PERMIT

SEWAGE DISPOSAL SYSTEM

HOWARD COUNTY HEALTH DEPARTMENT

SUBDIVISION Warfield Estates LOT 33 ROAD 14551 ~~325~~ MacClintock Drive

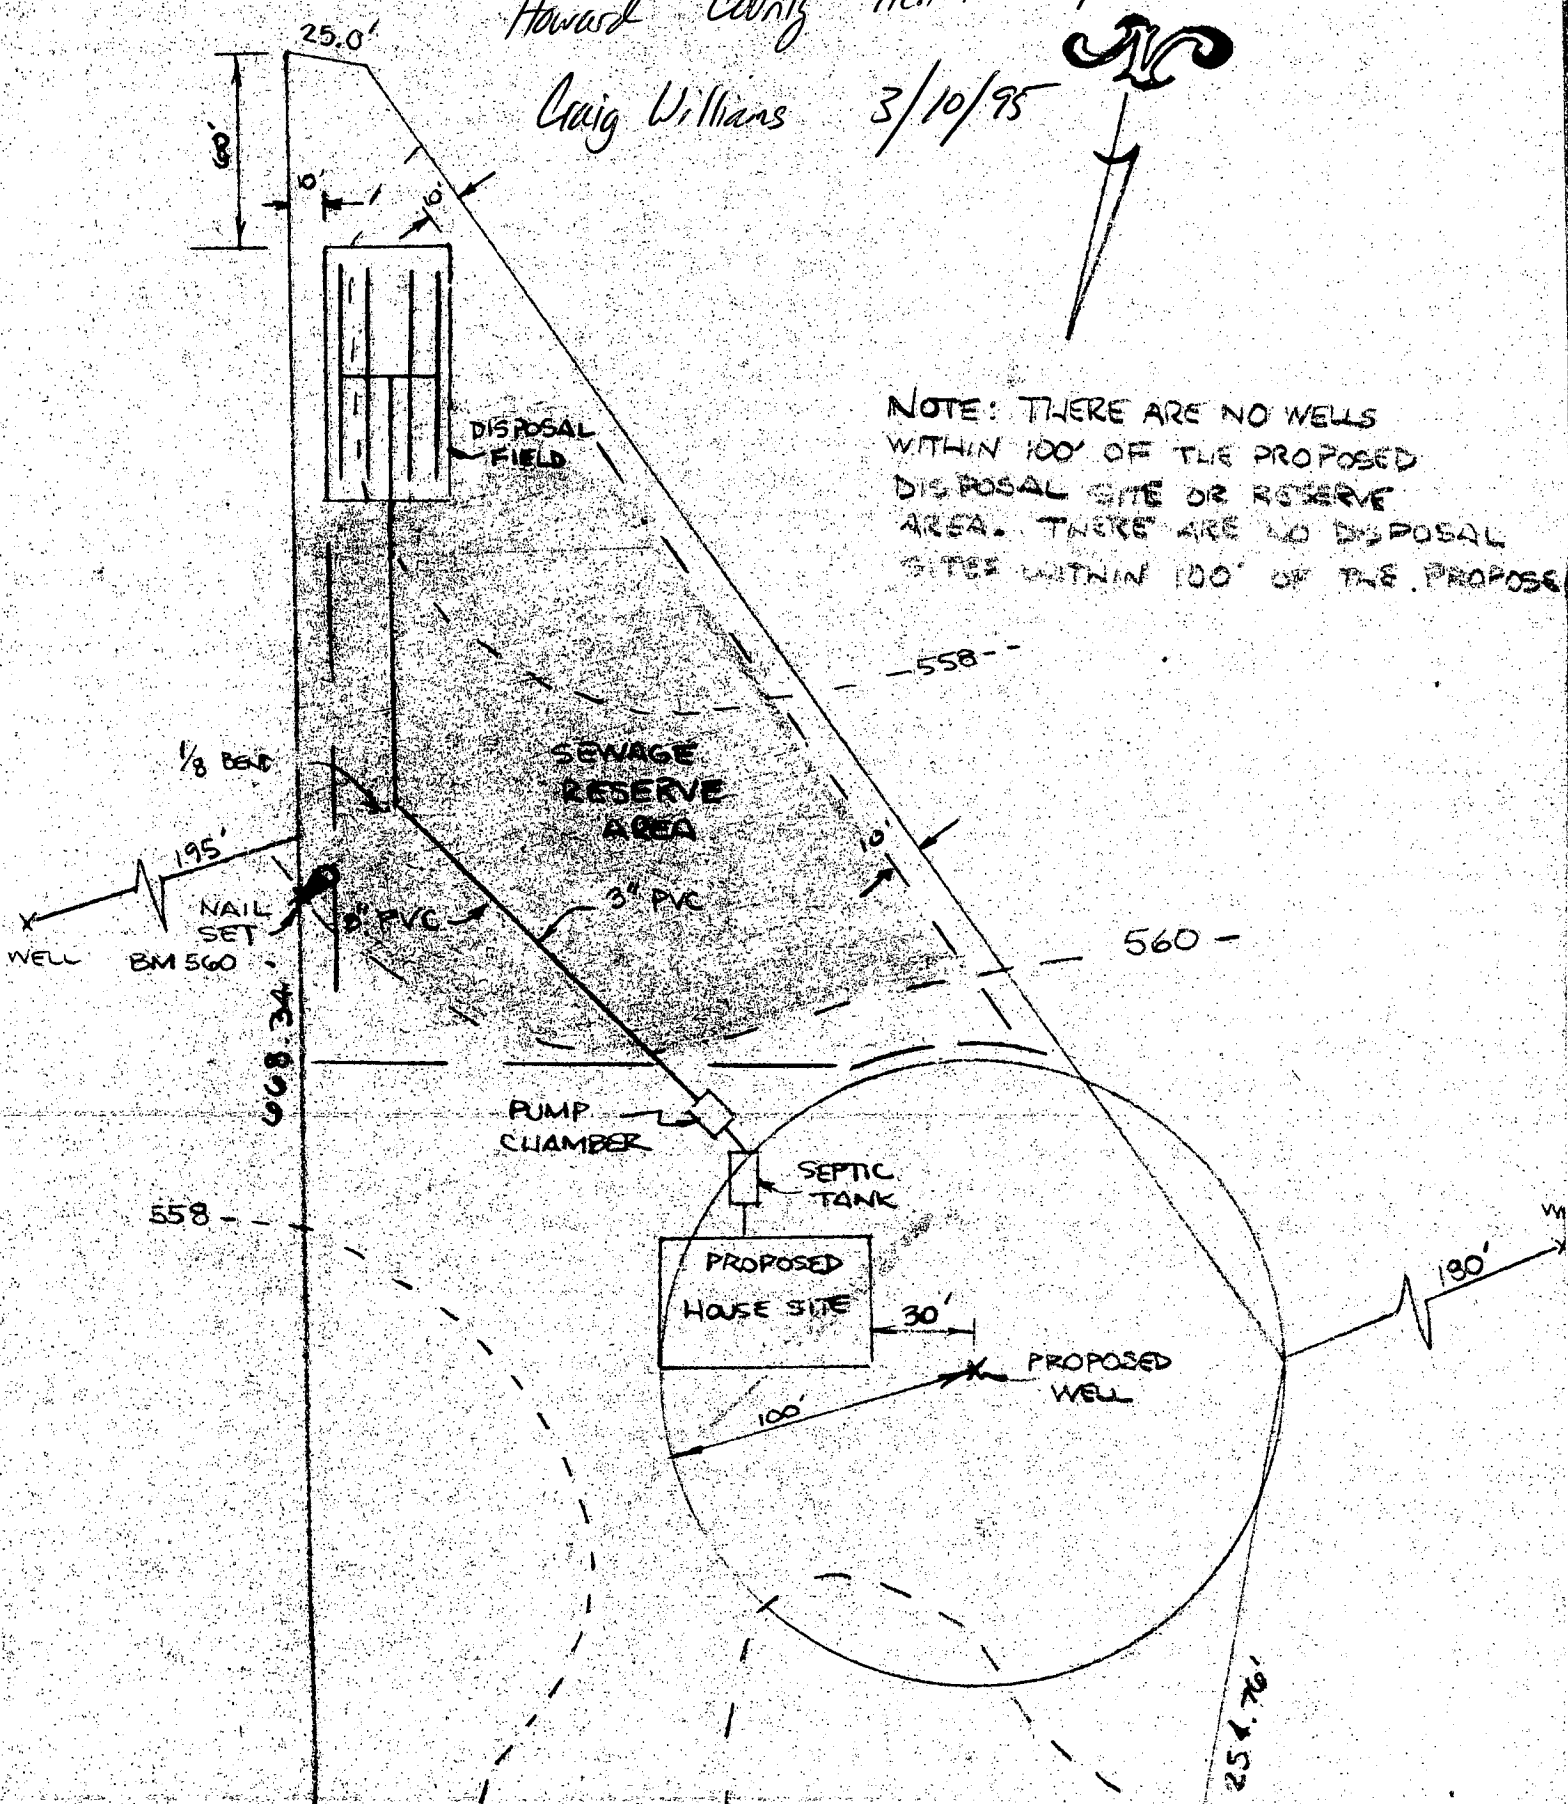
REMARKS: Pump Chamber & Septic Tank and House connection and last 20 ft of pressure 3" Sch. 40
are OK to cover RP 4/5/95 First 3 laterals sand + gravel filled, placing geo Textile fabric, 4th lateral being spread
ready for sand fill (Just penetrating good sandier soils at bottom 3-4 inches of Trenches) Supply line already
installed & covered. Sand Placed OK - ready for gravel, all lateral pipes already assembled & drilled OK RP 5/11/95
Last lateral trench OK to cover 5/15/95 Clean Box & Controls Installed in Basement OK, Pump Test OK RP
WPT - Pit less Napter OK at 4 1/2 ft RP 4/5/95 Pump Test OK

DETAIL 'A-A'
 SCALE: 1" = 30'

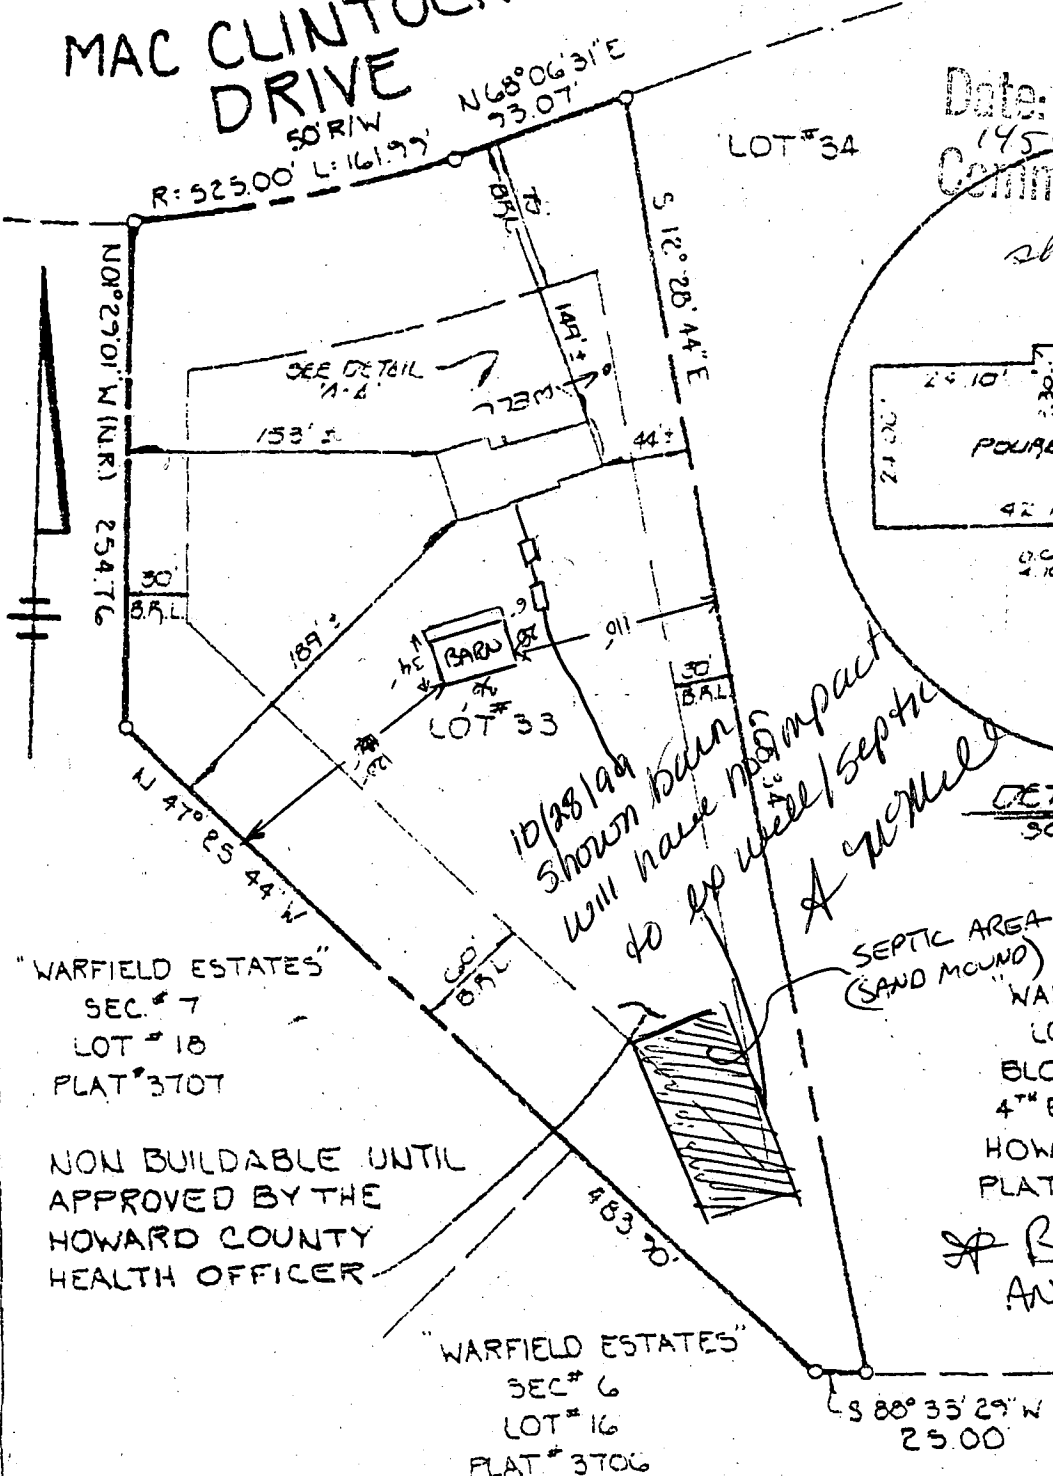
Date: 10-29-99
 14557 Mac Clintock Dr
 Comments: BOULDERS
 shown bar estate

10/28/99
 shown barn
 will have no impact
 do no well/septic
 A well

LOCATION DRAWING		SCALE:
#14561 MAC CLINTOCK DRIVE HOWARD COUNTY MARYLAND		1"=100'
JOHN C. MELLEMA SR., INC.		DATE:
LAND SURVEYORS		10-25-04
3409 EAST DRIVE BALTIMORE, MARYLAND 21227 (410)847-7488		JOB NO:
		04756

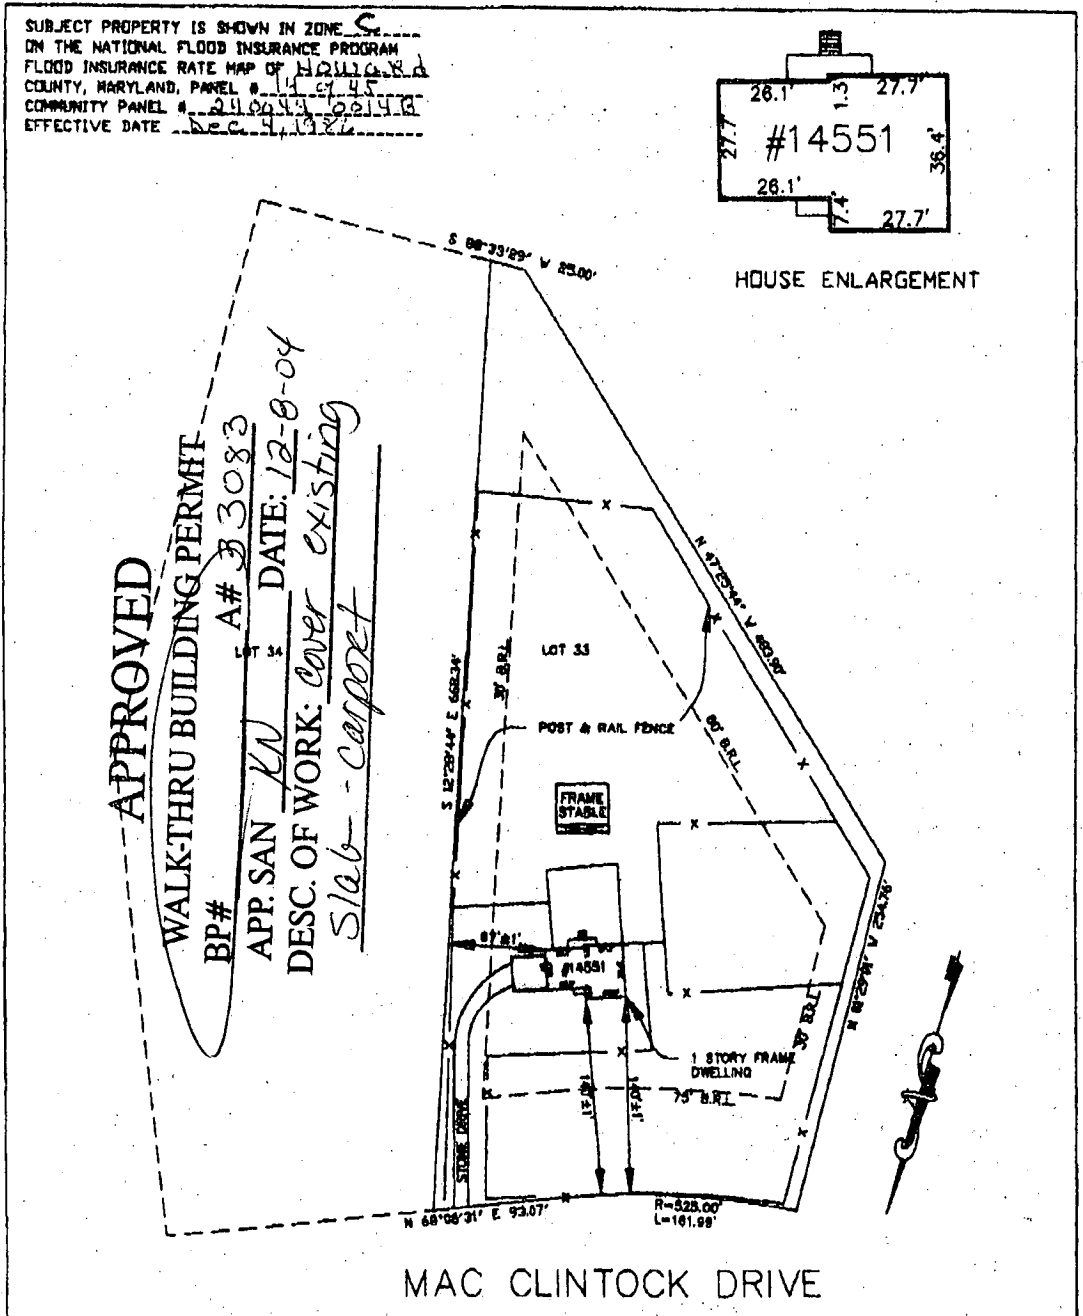
12-8-04 PLAN
 NOT TO SCALE, HOWEVER,
 IMPROVING UPON EXISTING
 "FOOTPRINT". OWNER
 AWARE FUTURE
 UPGRADES ON
 PROPERTY MAY/
 WILL REQUIRE
 SCALED DRAWING!
 No well or
 septic issues.

LOCATION DRAWING		SCALE:
#14551 MAC CLINTOCK DRIVE HOWARD COUNTY MARYLAND		1"=100'
JOHN C. MELLEMA SR., INC.		DATE:
LAND SURVEYORS		10-25-04
3409 EAST DRIVE BALTIMORE, MARYLAND 21227 (410)247-7488		JOB NO:
		04756

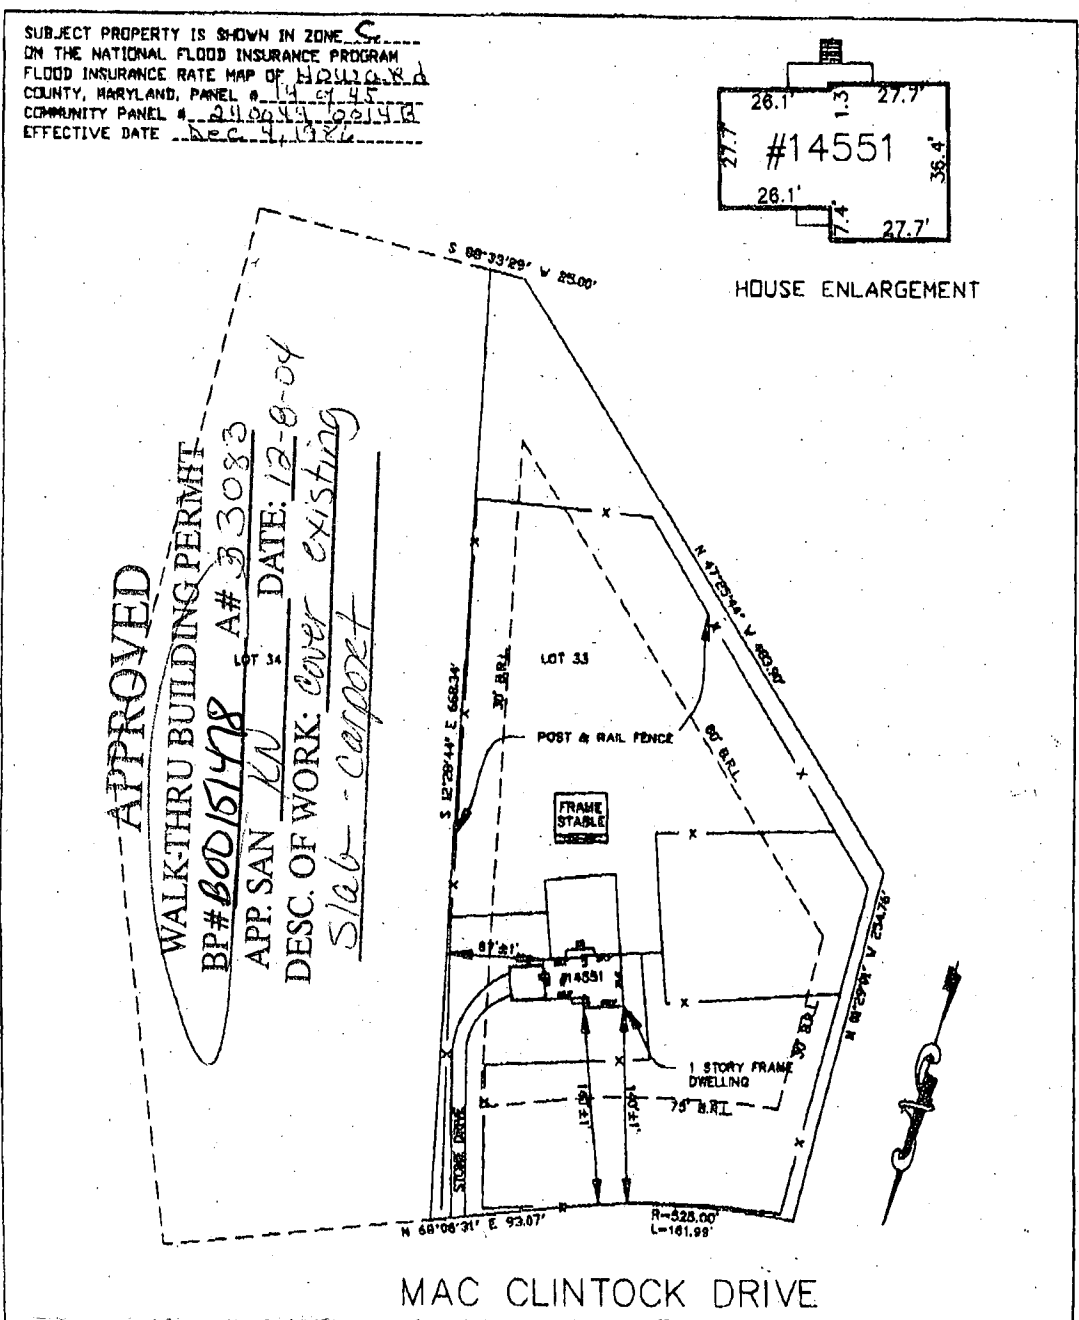
12-8-04 PLAN
 NOT TO SCALE, HOWEVER,
 IMPROVING UPON EXISTING
 "FOOTPRINTS" OWNER
 AWARE FUTURE
 UPGRADES ON
 PROPERTY MAY
 WILL REQUIRE
 SCALED DRAWING
 No well or
 septic issues
